UNITED STATES PATENT AND TRADEMARK OFFICE

APPLICATION NO.	FILING DATE	FIRST NAMED INVENTOR	ATTORNEY DOCKET NO.	CONFIRMATION NO.
10/765,117	01/28/2004	Goran Pantzar	024445-446	9711
55694	7590	01/30/2006	EXAMINER	
DRINKER BIDDLE & REATH (DC)			ROSS, DANA	
1500 K STREET, N.W.			ART UNIT	
SUITE 1100			PAPER NUMBER	
WASHINGTON, DC 20005-1209			3722

Office Action Summary

DETAILED ACTION

FIG. 11

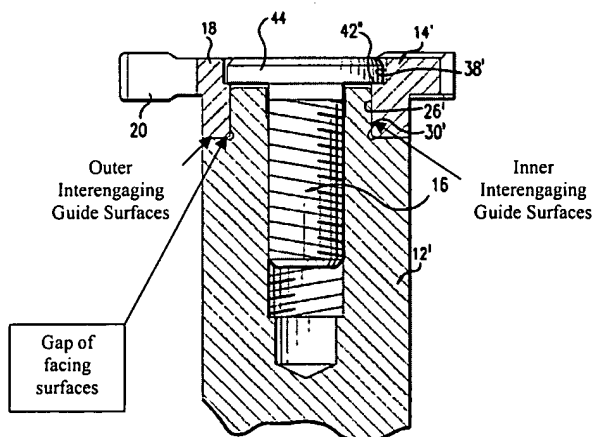
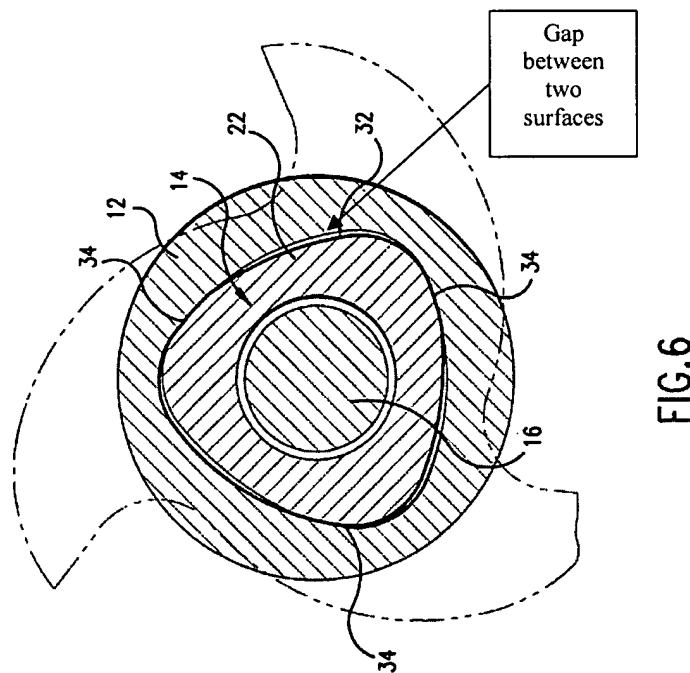
'263 teaches first and second bodies 14, 12 (see figure 4, for example), the first tool body 14 with a male member (area 22 of figure 4) and the second tool body 12 with a female member (area 50 of figure 4); outer and inner interengaging guide surfaces (see fig. 11 below); the male and female parts having a generally triangular cross section (see figures 1 and 3, for example); a force applying screw 16 (see figure 4, for example).

Regarding claim 1, as is seen in the above annotated Figure 11, and below Figure 6, '263 teaches the first and second tool bodies (12, 14) with first and second end surfaces facing each other in a non-contacting relationship when the tool bodies are connected (see also Figure 4 in the area located between the tools for another area of non-contact).
